9530 TRUELIGHT CHURCH RD

APPLICATION FOR IMPROVEMENT PERMIT FOR RESIDENTIAL SITE INDIVIDUAL WATER AND WASTEWATER SYSTEMS PROGRAM

SOIL/SITE EVALUATION
for ON-SITE WASTEWATER SYSTEM

PROPOSED PLOT PLAN

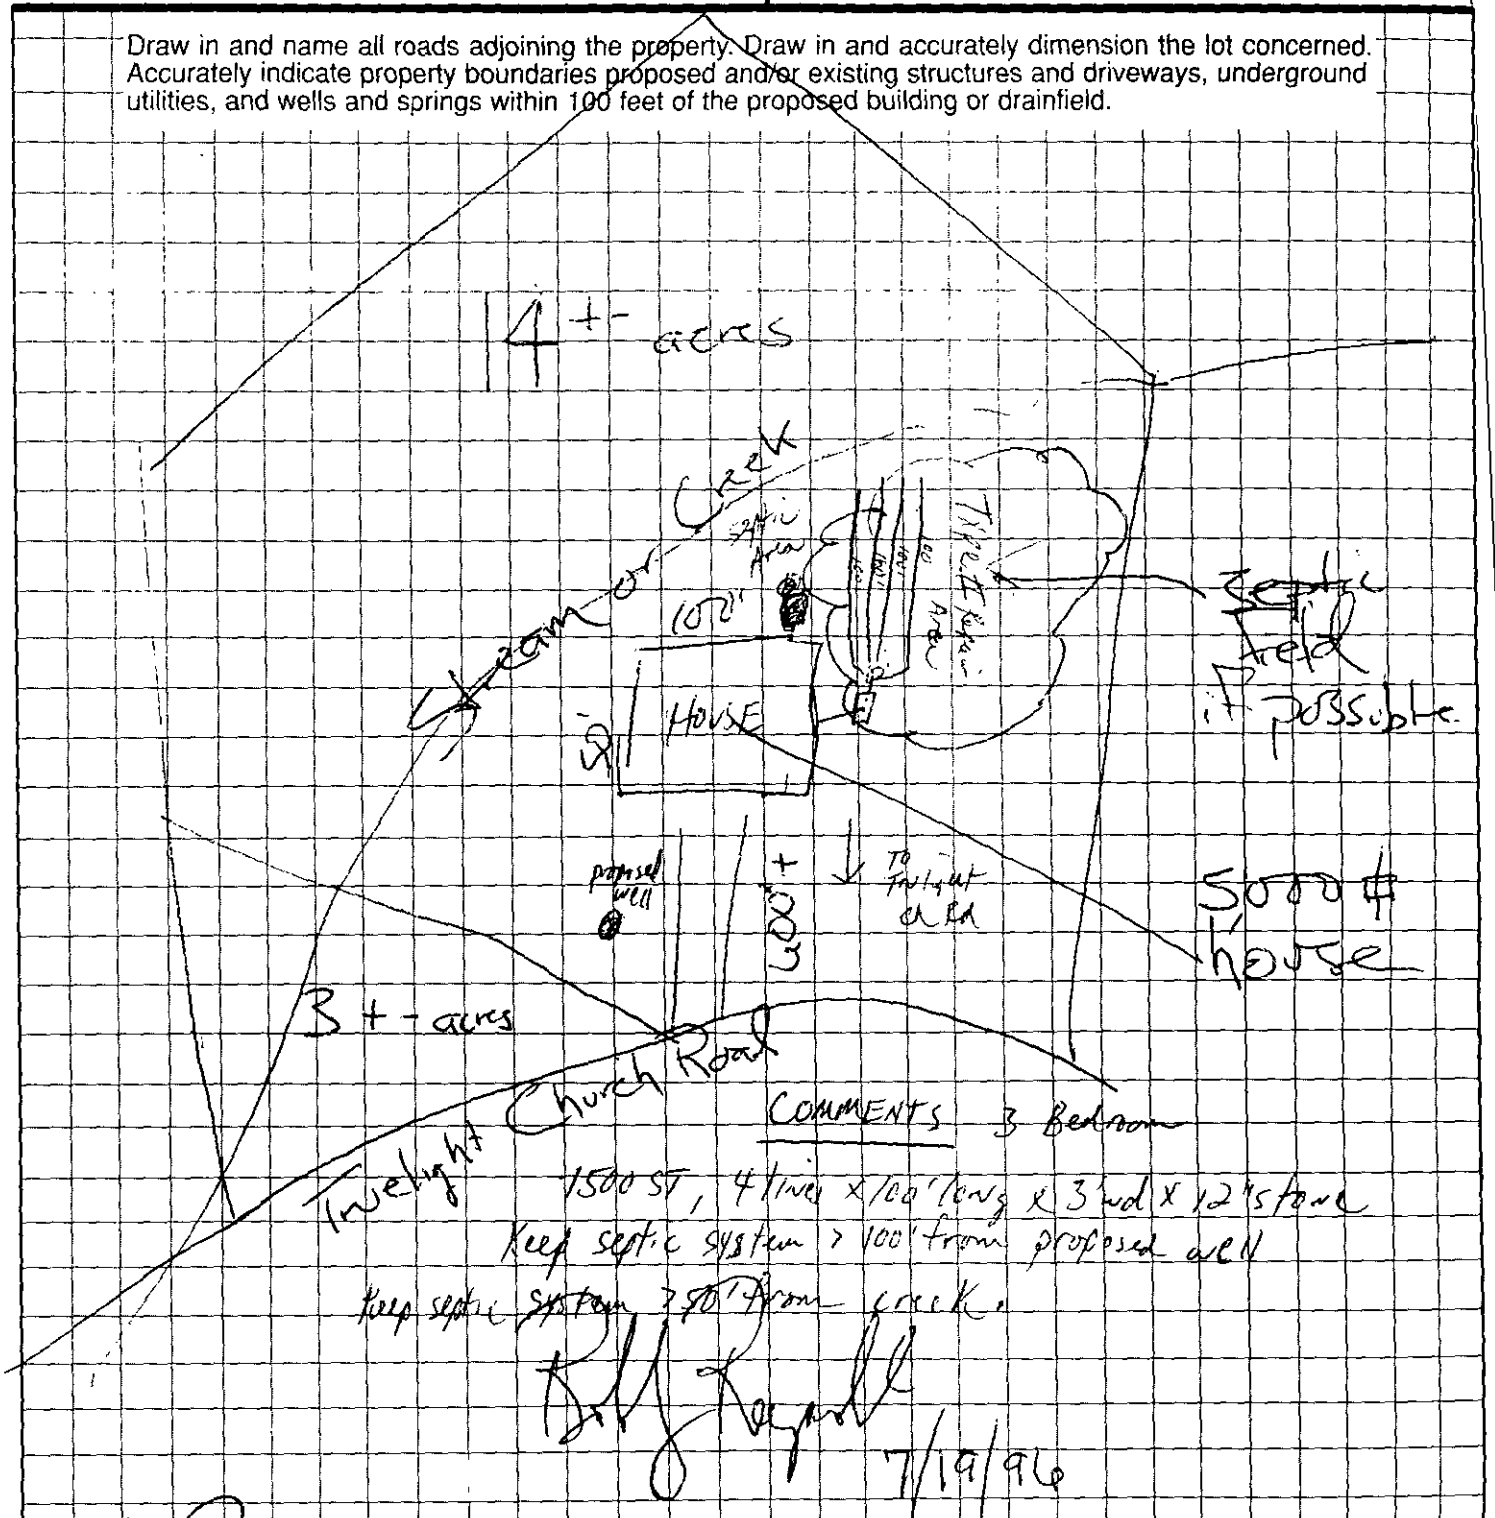
COMMENTS 3 Bedroom
1500 SF, 4 lines x 100' long x 3 wd x 12" stone
Keep septic system > 100' from proposed well
Keep septic system > 50' from creek.

PROPOSED PLOT PLAN

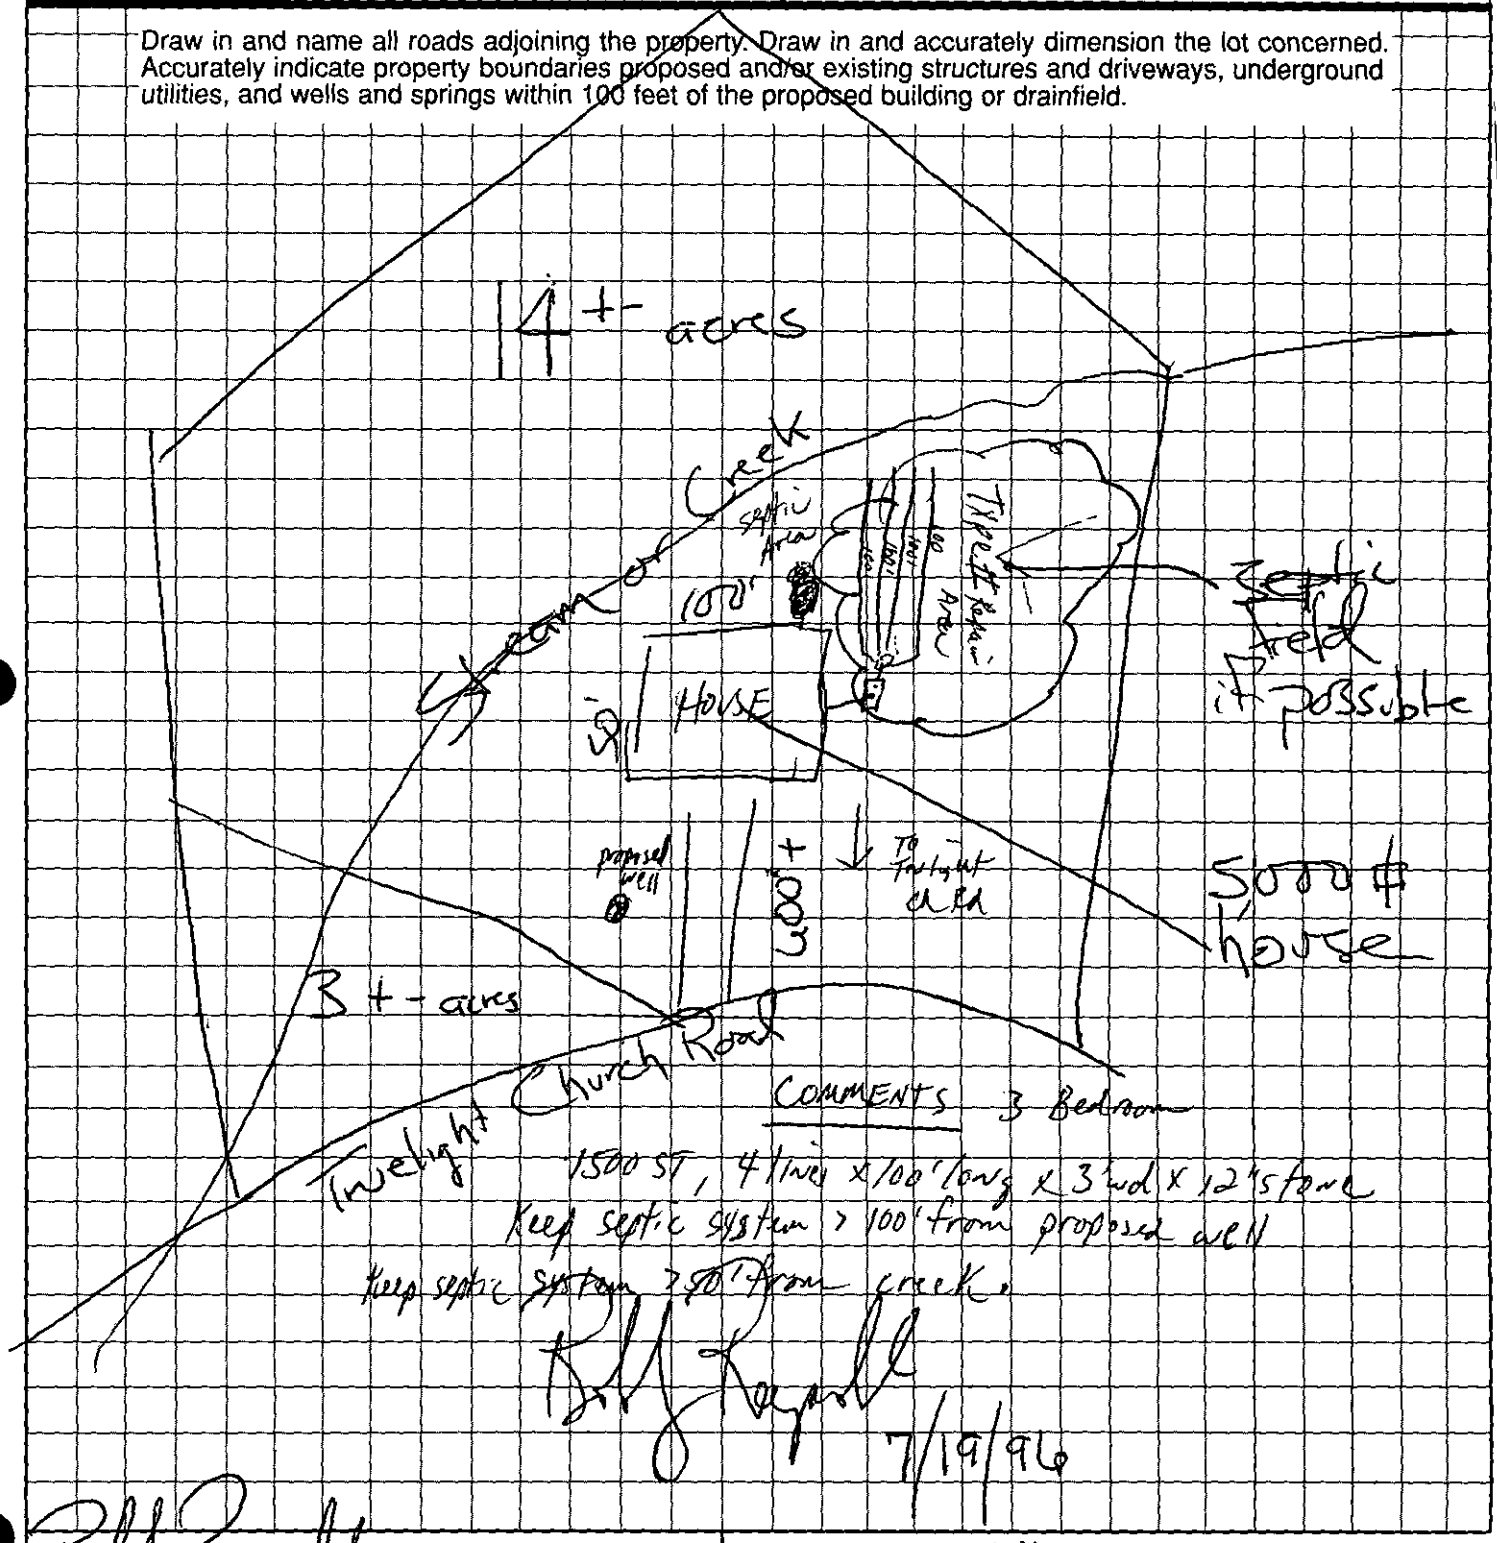
COMMENTS 3 Bedroom
1500 SF, 4 Line x 100' long x 3' wd x 12" stone
Keep septic system > 100' from proposed well
Keep septic system > 50' from creek.
